802.3dj D3.0 Comment Resolution Common Topics

- This slide package was assembled by the 802.3dj editorial team to provide background and detailed resolutions to aid in comment resolution.
- Specifically, these slides are for the various **common-topic** comments.

Figure 178B-10—Training control state diagram

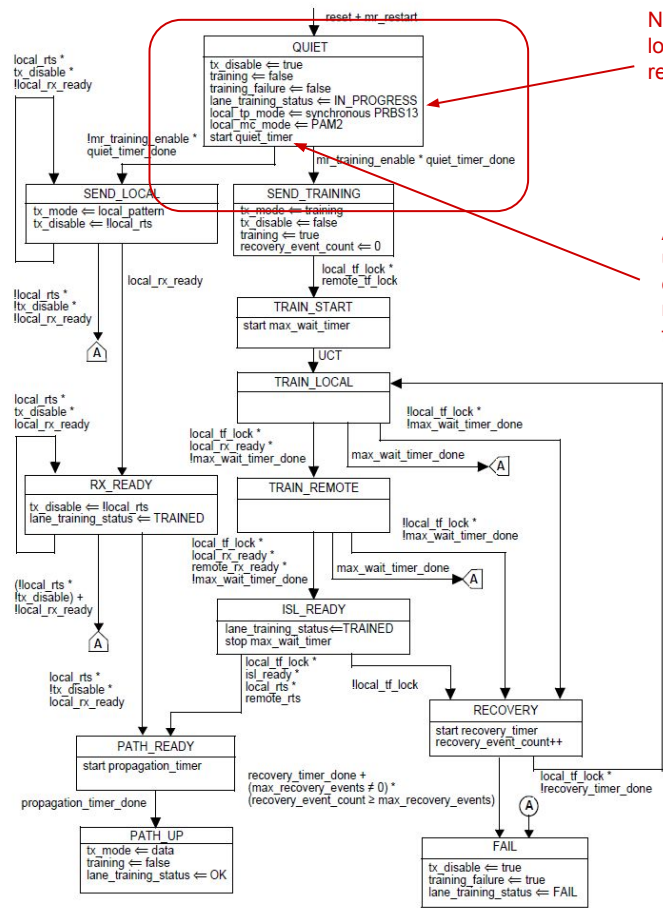
The behavior of the quiet_timer is somewhat ambiguous. The state diagram in Figure xxx shows the quiet timer being started in "QUIET" state. If reset or mr_restart are true then this state is "entered" continuous until both are false. So does this mean the quiet_timer is constantly reset until both reset and mr_restart are false? In this case, the quiet_timer would only start counter after exiting the quiet state. Or is the intent that the timer starts counting right away and if it has expired the transition out of QUIET state can immediately occur.

Add some clarity as to the intent. One option is to add an intermediate state that starts the quiet_timer when exiting the QUIET state and before entering the SEND_LOCAL or SEND_TRAINING states.

Ambiguous if timer starts upon entry to the state, or upon "reset + mr_restart" becoming false

Figure 178B-4—Signaling between RTS and ILT functions

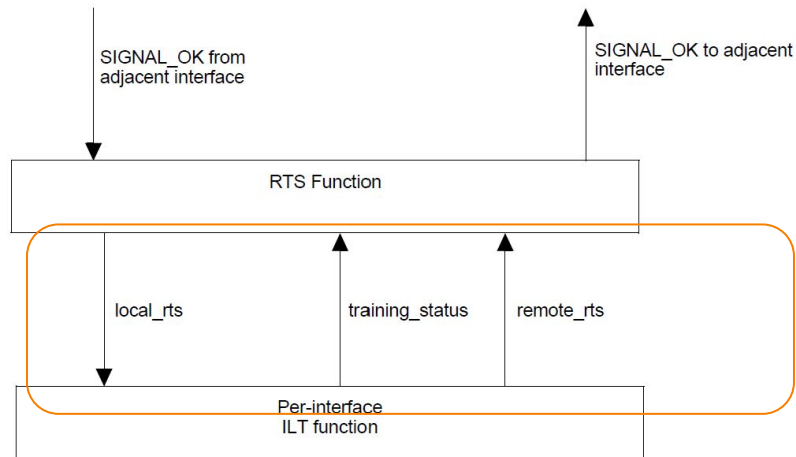
In Figure 178B-4, RTS function provide the state of the `rts_status` variable from a reference interface to its adjacent interface via `SIGNAL_OK`. However, if we are talking about host devices, the reference interface has no adjacent interface. Under this case, in the receive direction, `SIGNAL_OK` will be sent to PCS or DTE xXS by `IS_SIGNAL.indication` primitive.

Add a note to Figure 178B-4: If there is no adjacent interface, in the receive direction, `SIGNAL_OK` will be sent to PCS or DTE xXS via the `IS_SIGNAL.indication` primitive of PMA service interface.

PROPOSED REJECT.

The figure does show that `SIGNAL_OK` is a parameter of `IS_SIGNAL.indication`. See also section 178B.8.2.1 Variables `adjacent_signal_ok` and `adjacent_intf_rx_ready` and the note between them.

However, as noted by the comment in some cases there is no adjacent interface. In Figure 178B-4...

Change "SIGNAL_OK from adjacent interface"

to "SIGNAL_OK from the adjacent interface or from the sublayer above"

Change: "SIGNAL_OK to adjacent interface"

To: "SIGNAL_OK to the adjacent interface or to the sublayer above"
